CITY OF NEWPORT BEACH PUBLIC WORKS DEPARTMENT

Memorandum

Re: Proposed Dock Project at 511 36th Street - Revision

PROPOSED

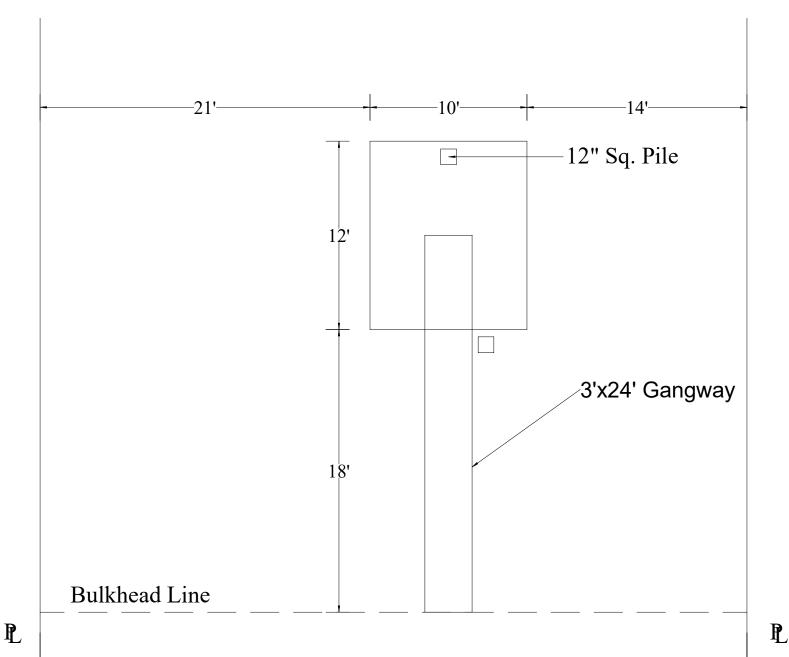
The applicant is proposing to reduce the size of the float from 10'x14' to 10'x12' to satisfy the Harbor Design Criteria which specifies 18' from the bulkhead to the backside of the float.
